MEMORANDUM

CITY OF WATERTOWN, NEW YORK
PLANNING AND COMMUNITY DEVELOPMENT DEPARTMENT
245 WASHINGTON STREET, ROOM 305, WATERTOWN, NY 13601
PHONE: 315-785-7741 – FAX: 315-782-9014

TO: Planning Board Members
FROM: Michael A. Lumbis, Planning and Community Development Director
PRIMARY REVIEWER: Geoffrey T. Urda, Planner
SUBJECT: Site Plan Approval – 155 Clinton Street
DATE: July 27, 2023
Request: Site Plan Approval to construct a 2,378 SF building addition, a 253 SF building addition and a 9,500 SF sq. ft. parking lot expansion at **155 Clinton Street**, Parcel Number 10-07-109.100
Applicant: Design Build Innovations, LLC
Proposed Use: Professional Office Building
Property Owners: Clinton Center Development, LLC

SHEET TITLE:
△ SITE UTILITY AND GRADING PLAN

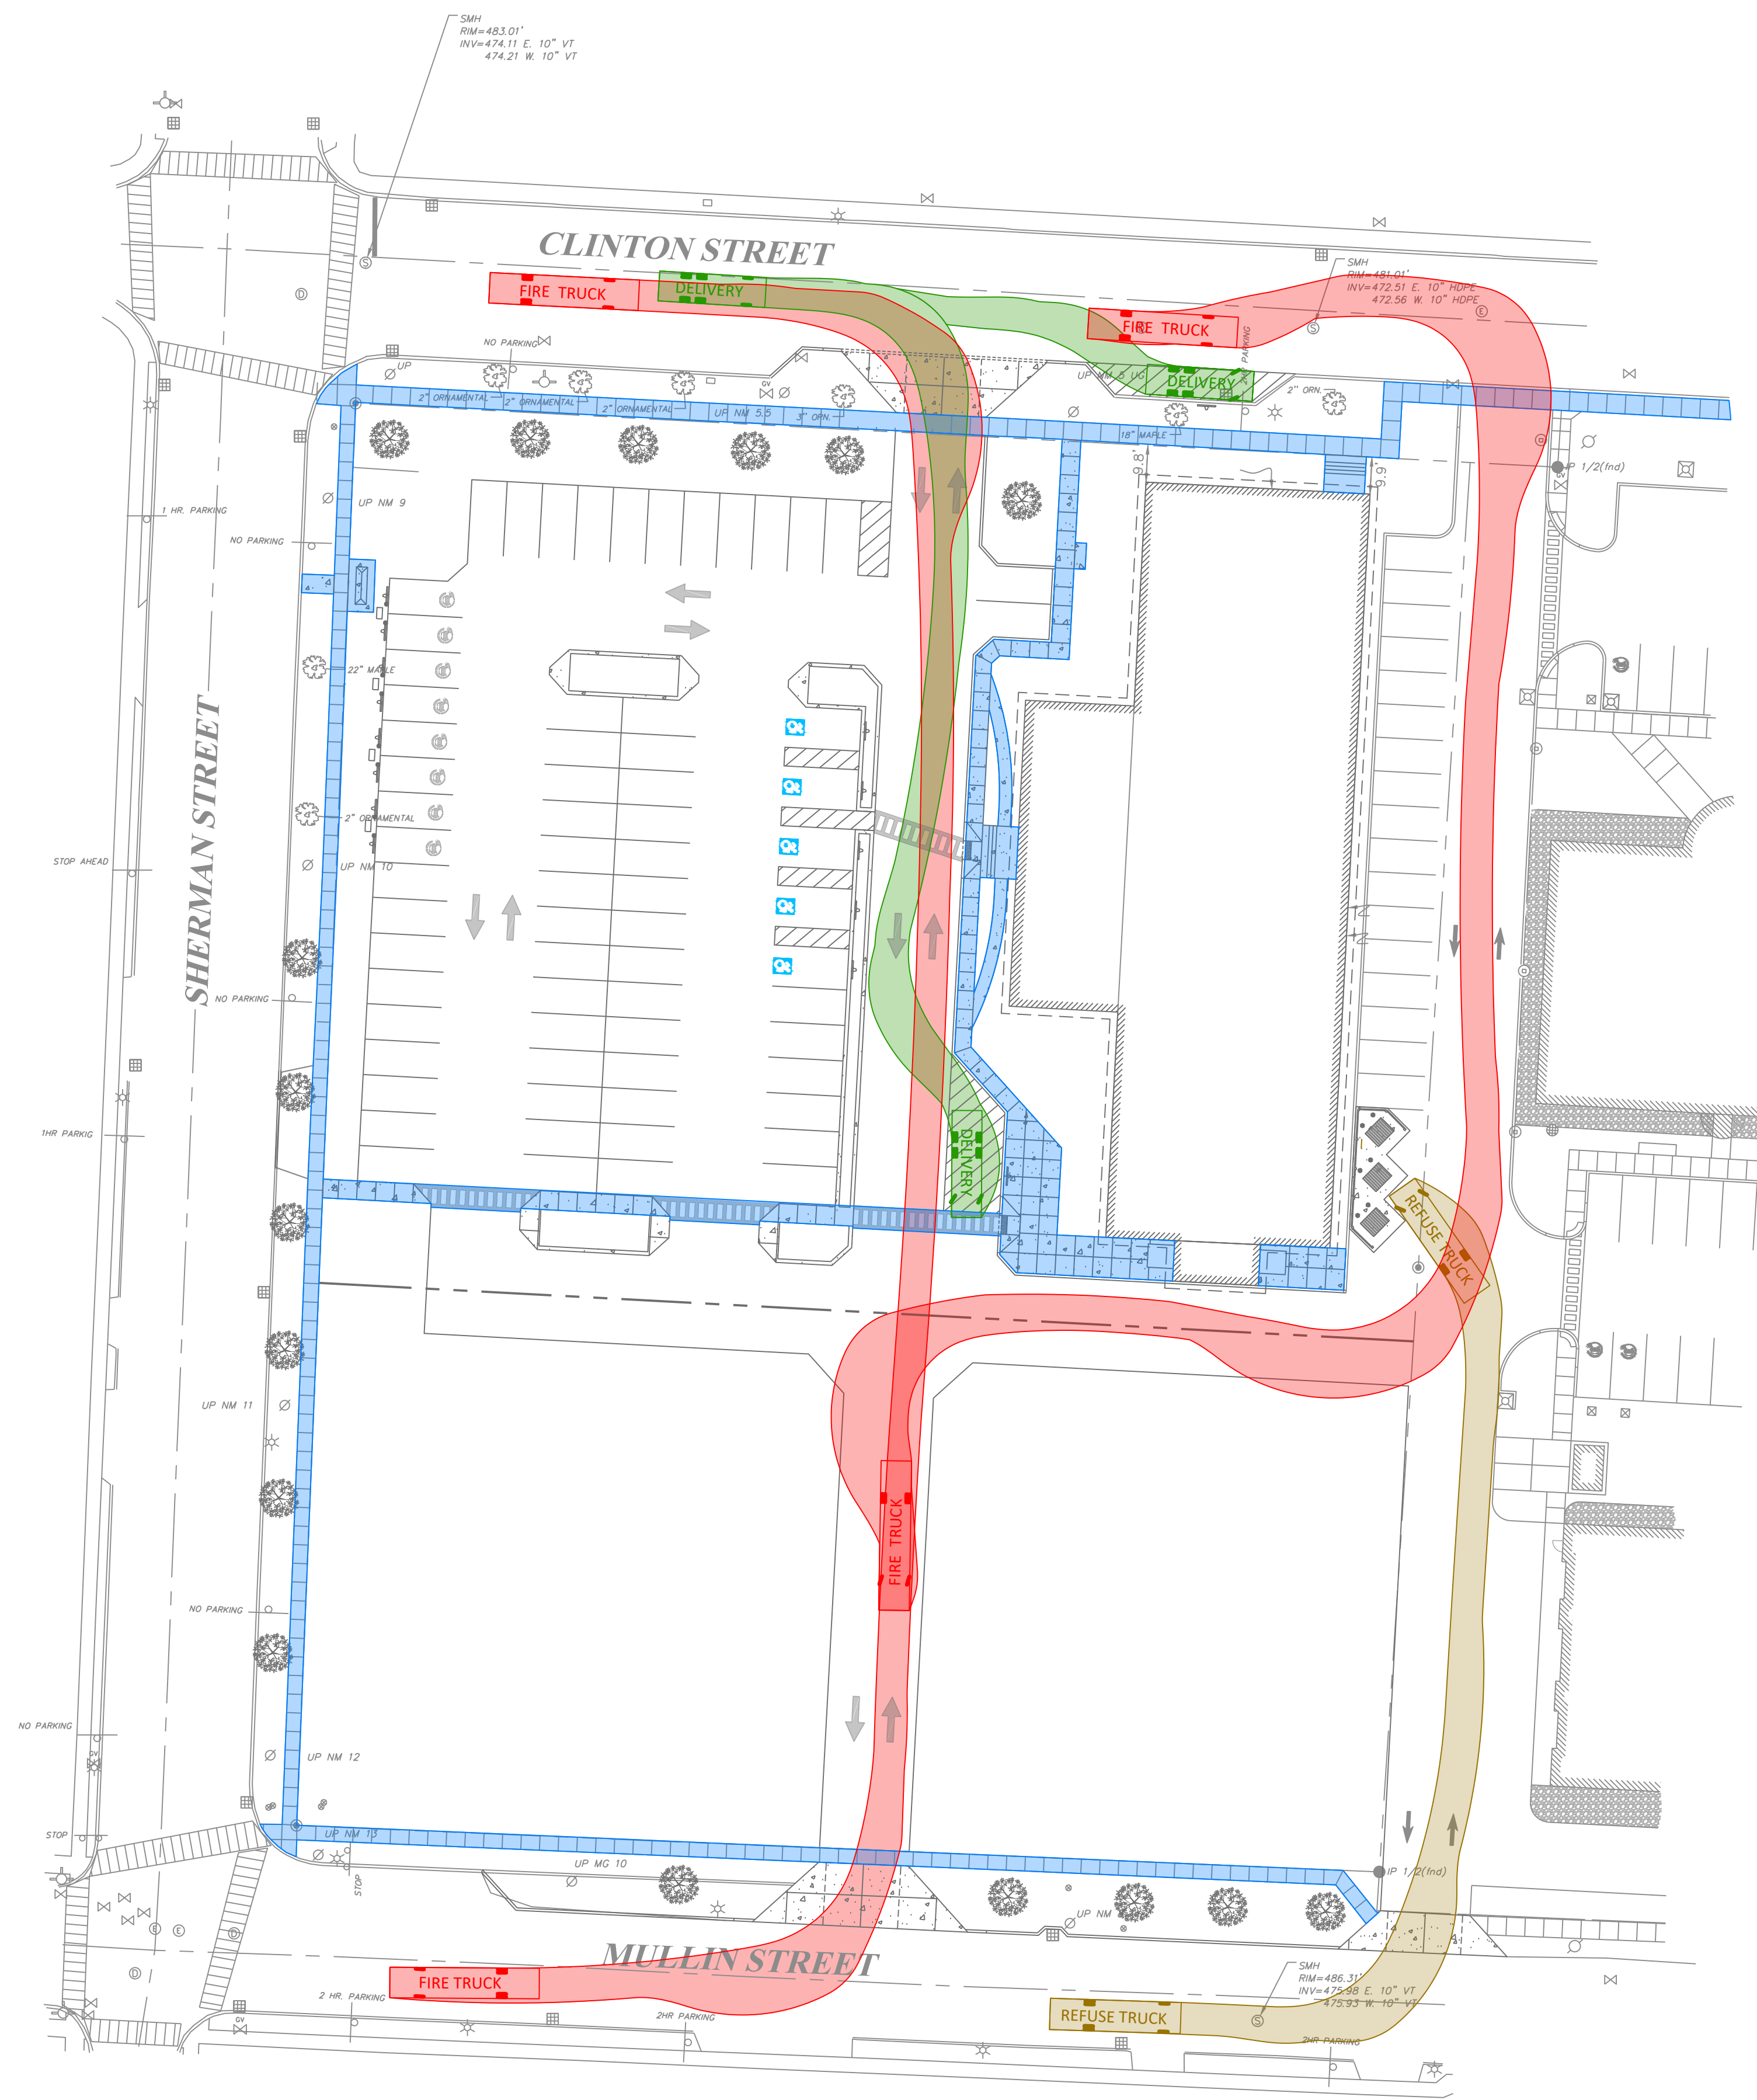
8. The applicant shall clarify what is proposed regarding the existing storm sewer line connecting from Clinton Street and the catch basin it connects to, as it relates to the sanitary sewer line depicted on the C103 drawing. *This item is satisfied. The applicant has added a C101 (Demolition Plan) drawing to the set that depicts all proposed cuts, removals and abandonments to the satisfaction of the City Engineering Department.*

11. The applicant must either add grading, invert elevation information, pipe slopes and other pertinent data to the C103 drawing or submit a dedicated Grading Plan drawing with all required information. *While the applicant has added Rim Elevations to the C103 drawing, the Engineering Department will not be able to consider this condition satisfied until the applicant has submitted final construction drawings. This summary item must remain but should be reworded as the following: “The applicant shall submit a copy of the final construction drawing set, which must include all final inverts and grading information, to the City Engineering Department prior to the issuance of any permits.”*

12. The applicant must add a construction detail and note to the plans providing information regarding the proposed manhole boot connector that will be required for connection to the City catch basin. *While the applicant attached the required detail sheet to the July 19, 2023 correspondence (cover letter). These details must be part of the actual plan set on a dedicated detail sheet.*

13. The applicant shall be prepared to clarify where their roof drains are proposed to connect to. *The applicant states in the July 19, 2023 correspondence that all roof drains are internal to the existing building and will drain to the sanitary sewer. However, the applicant must calculate the expected outflow from the roof and call this calculation out on the C103 drawing.*

Grading, Drainage and Utilities: The C103 (Utility Plan) depicts a sanitary sewer line extending south from Clinton Street to the proposed western building addition. There is an existing storm sewer line in that location now (see image on next page). There is also an existing catch basin at the south end of the storm line that would be directly underneath the proposed western building addition.

The applicant shall clarify to the City Engineering Department exactly what is proposed for this pipe and catch basin. If both are proposed for elimination, the applicant shall add a note to the site plan to that effect and clarify for Staff if this will be mitigated elsewhere on the site.

Both the C102 and C103 drawings contain contour lines. It appears that these are existing contours. The applicant must add a label to one of the drawings calling out the nature of the contour lines.

The applicant did not submit a Grading Plan and there are no proposed contours or spot elevations shown on the site utility plan. The applicant is proposing several landscaped islands containing yard drains with steel domed covers, connected by 6” HDPE pipe. This parking lot drainage system connects to a City catch basin located at the southeast corner of the Clinton St./Sherman St. intersection. The applicant must either add grading, invert elevation information, pipe slopes and other pertinent data to the C103 drawing or submit a dedicated Grading Plan drawing with all required information.

Additionally, the City will require a manhole boot connector (a.k.a.: boot style connection) in the City catch basin. The applicant shall also add a construction detail and note providing information regarding the proposed connection to the City catch basin.

WEST EXTERIOR ELEVATION VIEW
SCALE: 1/8" = 1'-0"

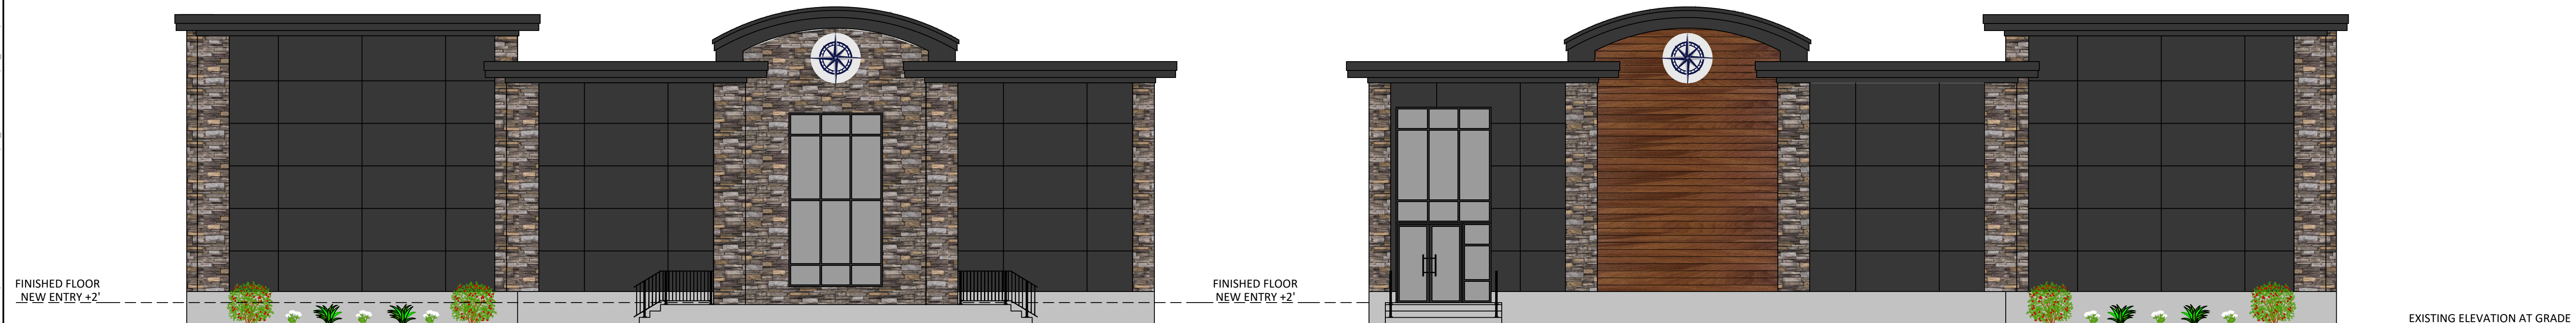
1. The applicant shall submit transparency calculations for the proposed building facades and must either increase transparency levels to meet the requirements of the Zoning Ordinance or apply for and obtain an Area Variance from the Zoning Board of Appeals granting relief from the requirements. *The applicant has submitted an Area Variance application, as discussed above, and provided proposed transparency calculations as part of that application. These calculations are also included as part of this resubmission. However, as the proposed transparency falls short of the Zoning Ordinance's requirement for the Downtown District, it could be legal only with the relief of an Area Variance. Therefore, this summary item must remain but should be reworded as the following: "The applicant shall obtain an Area Variance from the Zoning Board of Appeals granting relief from the transparency requirements for all proposed building façades that would fail to meet the required percentages."*

The applicant did not include transparency calculations with the submitted elevation drawings. However, the applicant is responsible for submitting those calculations, and if the applicant seeks less transparency than the Zoning Ordinance requires, then such a reduction in transparency could only be legal with the relief of an Area Variance granted by the Zoning Board of Appeals. While the applicant did not include transparency calculations, it is evident from a cursory review of the elevation drawings that the ground-floor requirements are not being met.
